File Number: 8-B-26-IH

Meeting: 8/19/2026
Applicant: R. Eberto Arellano ROE Construction, LLC
Owner: Jorge Mercado
District: Lonsdale Infill Housing Overlay District

Location: 3359 Midway St. **Parcel ID:** 81 H C 017
Zoning: RN-2 (Single-Family Residential Neighborhood), HP (Hillside Protection Overlay)
Description: New primary structure

8-B-26-IH
APPLICATION FOR CERTIFICATE OF APPROPRIATENESS

EXTERIOR ELEVATIONS

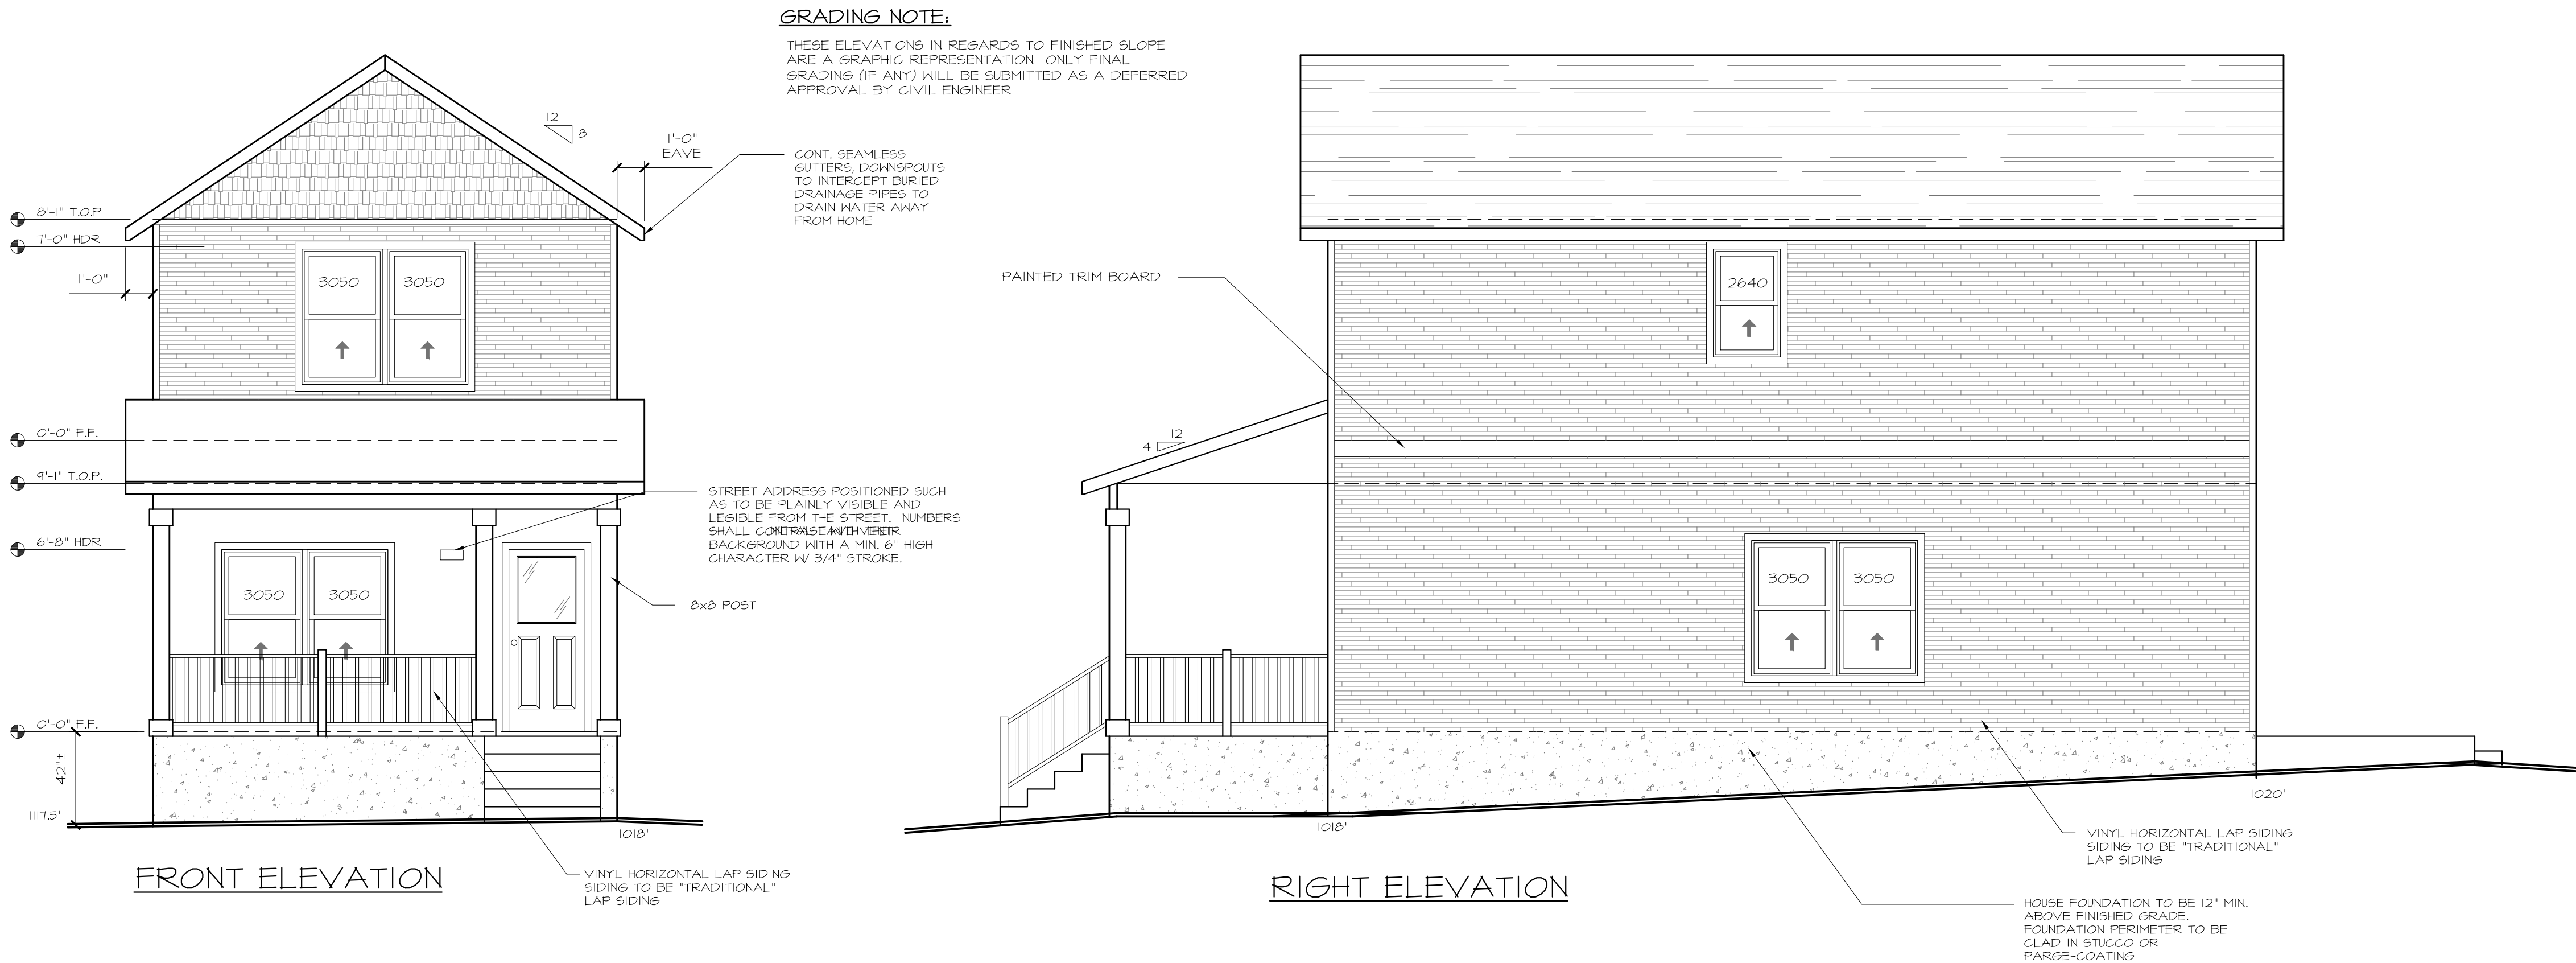
The two-story building features an exterior of lap siding with shakes in the gable fields and trim dividing the stories, an 8/12 pitch front-gable roof with overhanging eaves, and a block foundation that will be clad in stucco or parge-coated and measures 3'-6" tall at the façade and 1' tall at the rear elevation. The façade (east) features a full-length, 8' deep front porch with a shed roof that is supported by three 8" square posts, paired windows and a half-lite paneled door on the first story, and paired windows on the second story. The right elevation features paired windows on the first story and one window on the second story, and the left elevation features one window on each story. The rear elevation features paired windows on the second story and one window and a secondary entrance with a landing on the first story.

Scale, Mass, and Foundation Height: The block primarily features Minimal Traditionals and Craftsman bungalows that are all one-story or one-story with a basement level, and two-story infill construction was approved and constructed this year. The visual scale of the two-story house is mitigated by the trim dividing the stories and the deeper front setback to the main massing relative to the adjacent houses. The lot is also narrower than most houses on the block, but the width is appropriate given the topography and irregular shape of the lot.

- 1) the final site plan to meet City Engineering standards, with minor revisions to be approved by staff;
 - 2) major changes to the foundation height to return to the Board for review;
 - 3) allowing for an 11' combined side setback because it is compatible with site constraints and surrounding development.
-

FIRST
SECOND
FLOOR PLANS

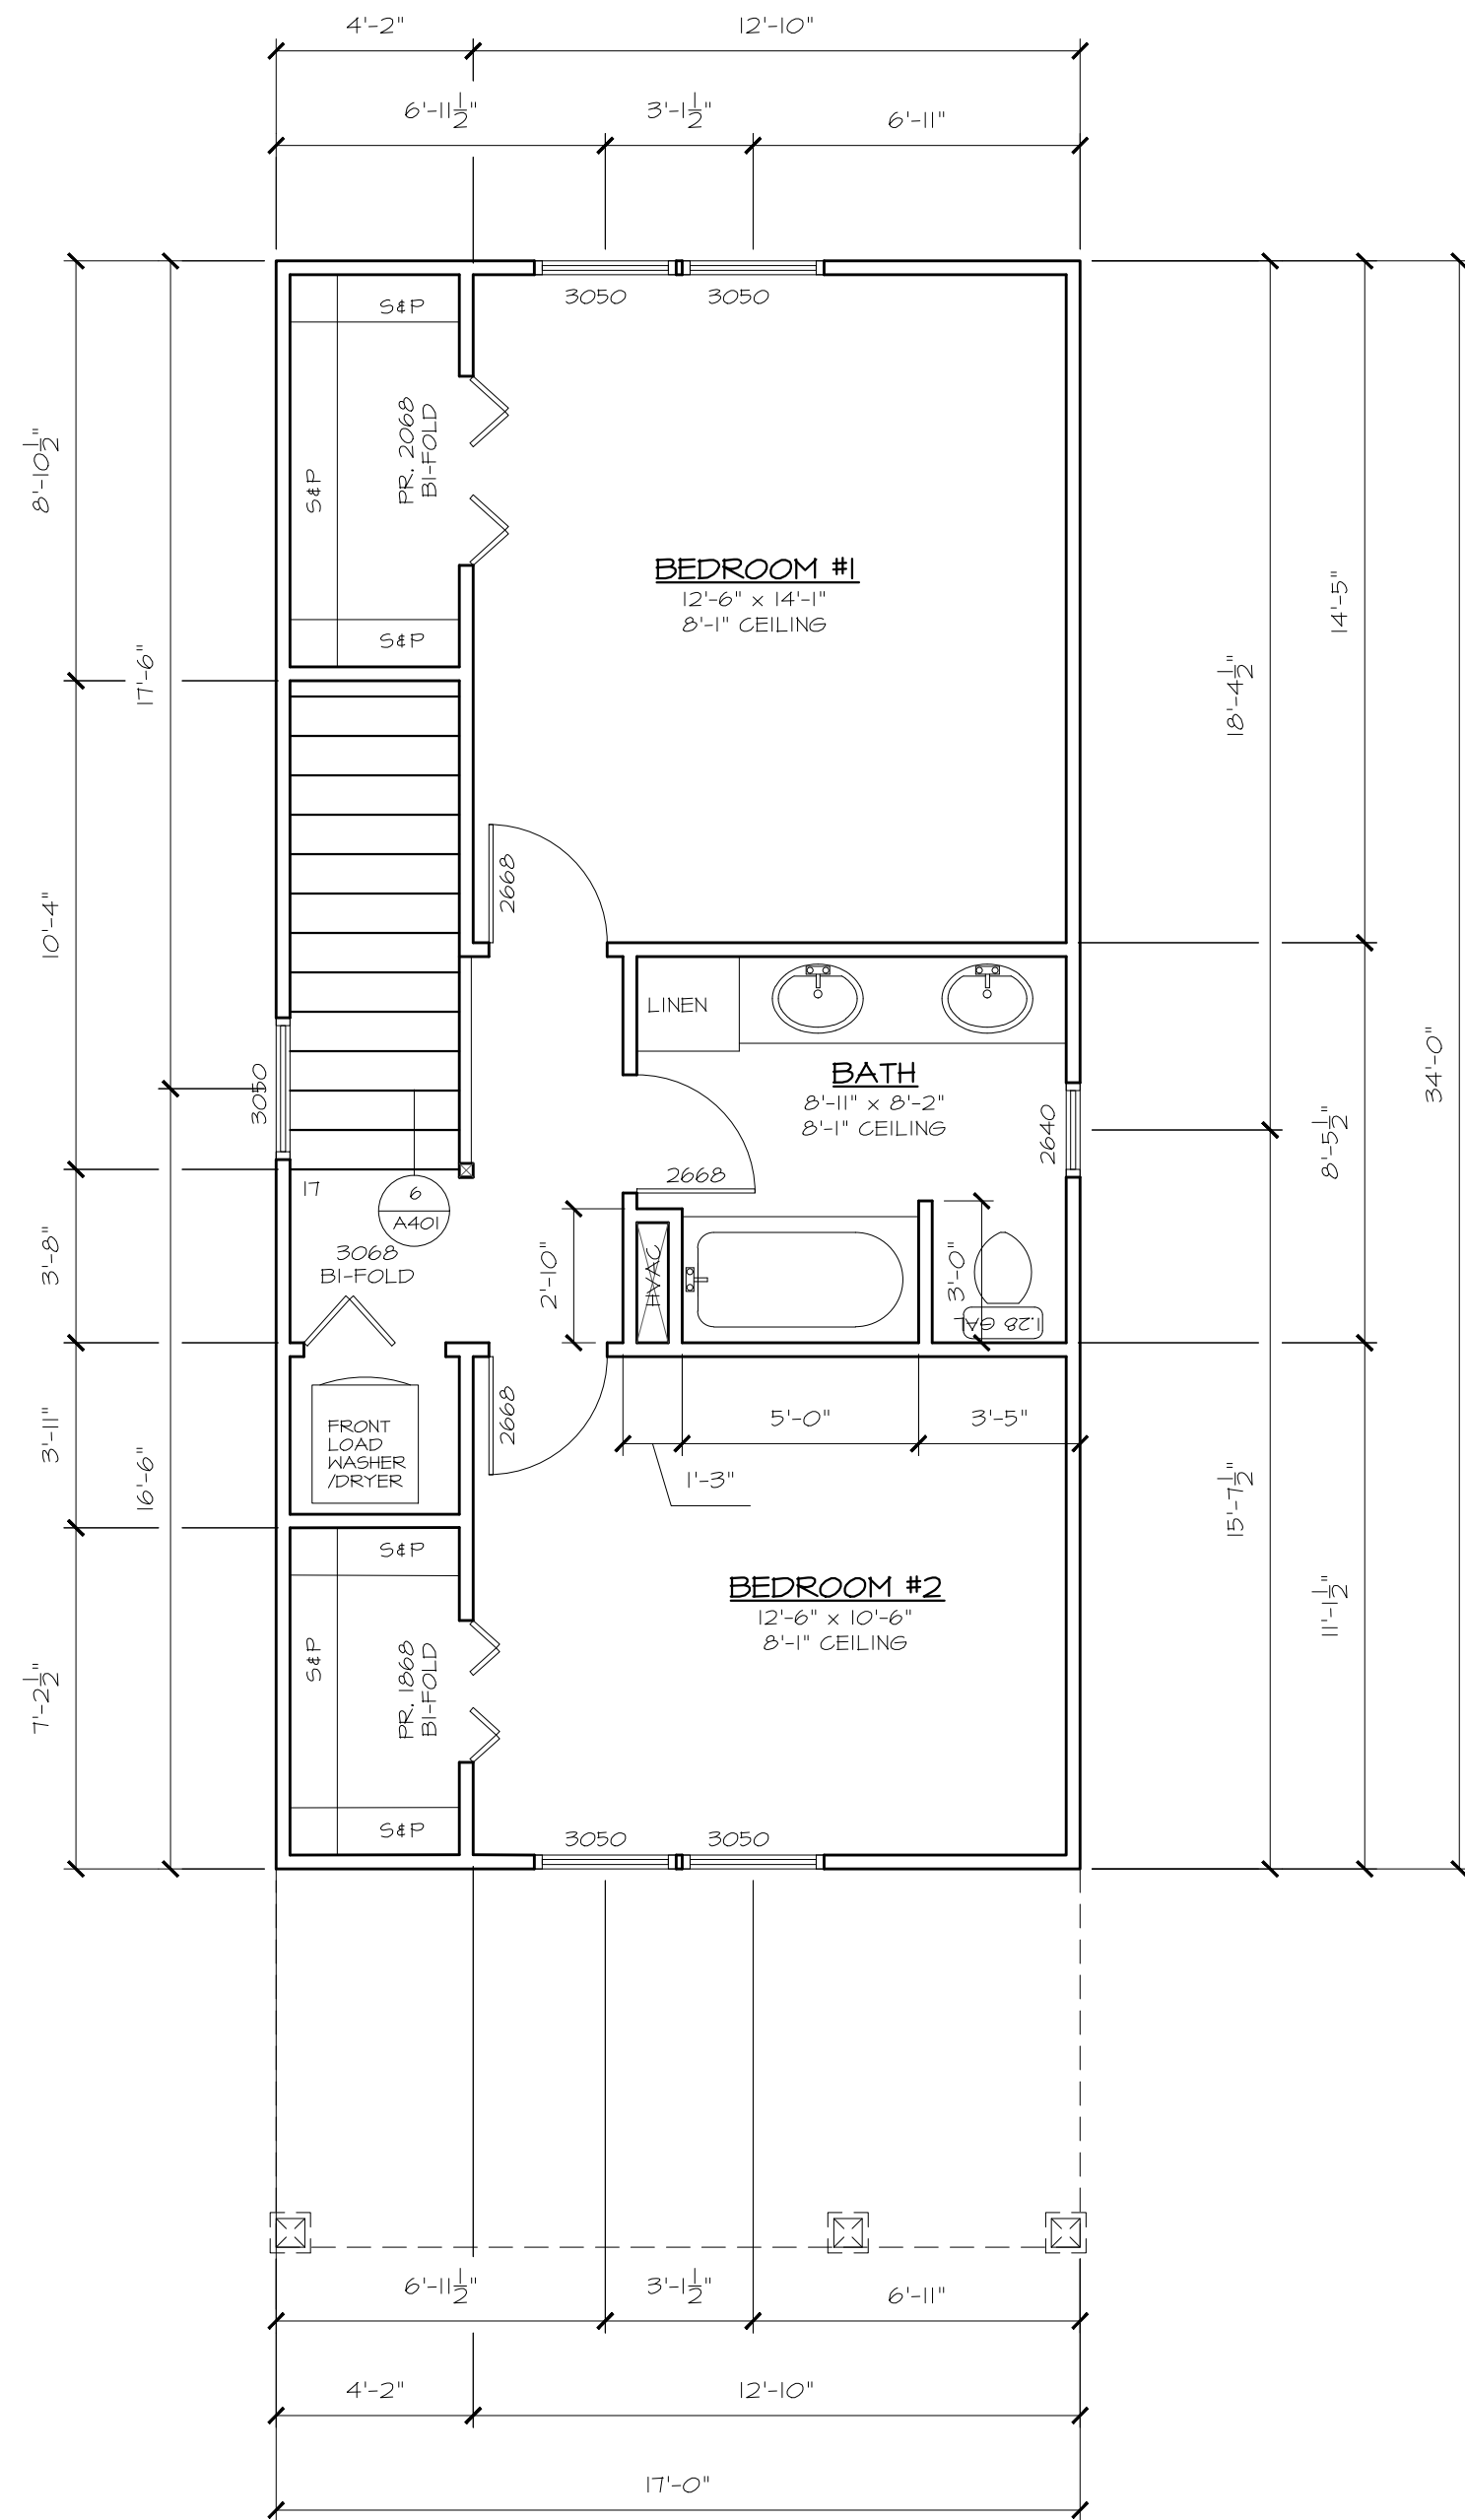
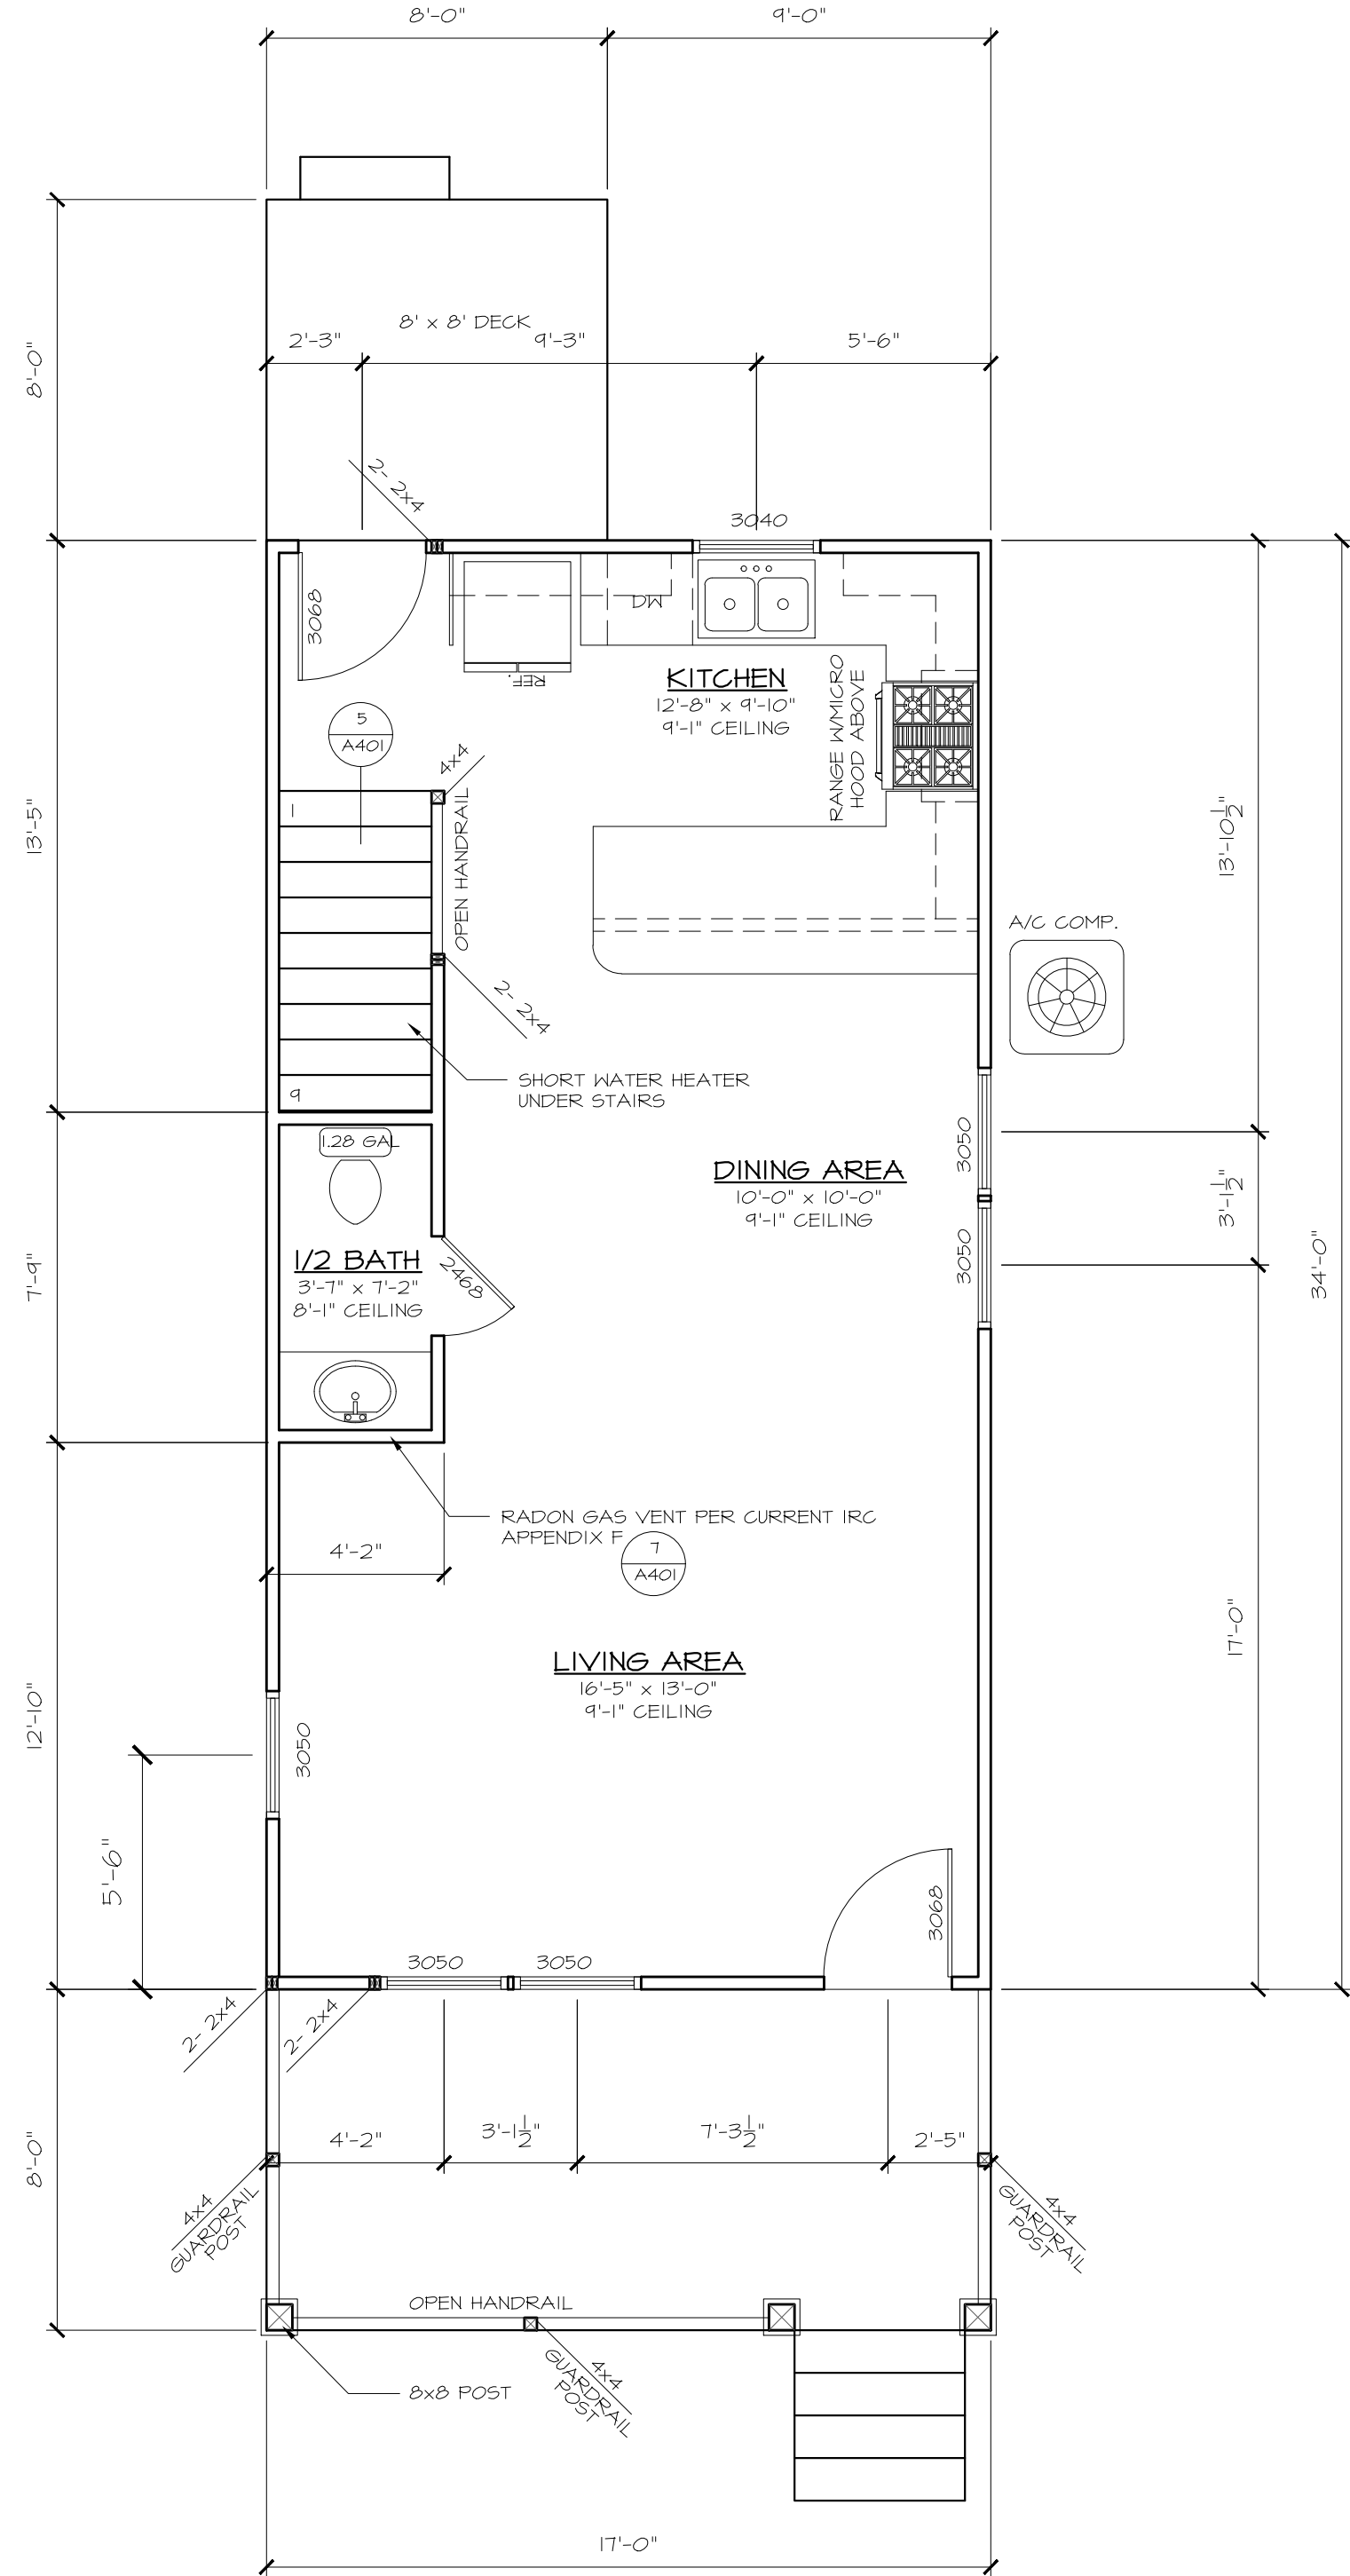
New primary structure fronting Midway Street. The house measures 17' wide by 34' deep and is proposed to be set 26' from the front property line (18' to front porch). Parking is a driveway accessed via Midway Street that leads to a parking pad next to the house. The site plan features a walkway from the porch to the street and a tree in the front and rear yards.

House Orientation and Side Yards: There is a 5' setback on the south side and a 6' setback on the north side, which does not meet the minimum 15' combined side setback of the RN-2 (Single-Family Residential Neighborhood) district. The DRB has the authority to approve alternative dimensional standards if they "realize the principles associated with the guidelines" (16.6.D.1). The block features historic construction with small side setbacks that do not comply with current zoning requirements, and the subject property has an irregular, triangular shape and steep areas that make compliance with the combined side setback standards challenging. In the opinion of staff, the proposed side setbacks are appropriate.
